Product Change Notification

Change Notification #: 112079 - 00
Change Title: Intel® Front Panel Spare FXXFPANEL
PCN 112079-00, Product Design
Update Front Panel Spare Transparent
Window Size, Power Button LED and Tube
Material

Date of Publication: March 06, 2013

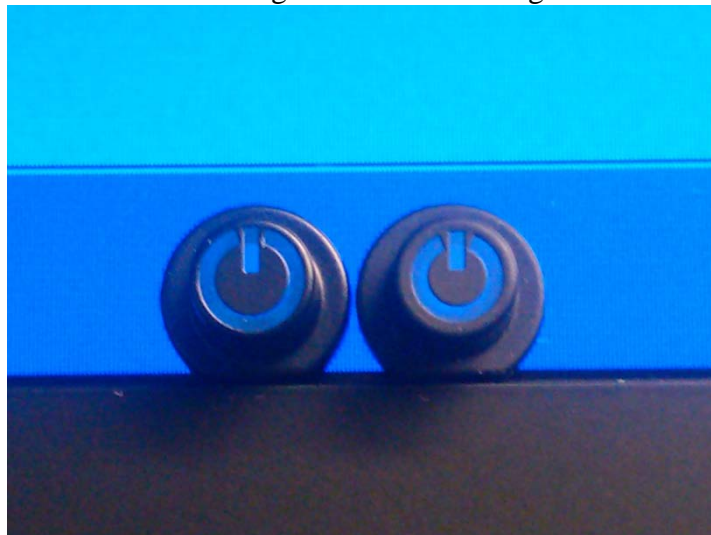
- Changed the power button cap icon outer diameter from 4.0mm to 3.5mm. The transparent area on the post-change button is more centralized than on the pre-change one. The purpose of this change is to make the button brighter. The post change button icon is smaller, but more of the icon area is directly illuminated by the LED. See the picture below for an illustration of Pre-change and Post-change material:
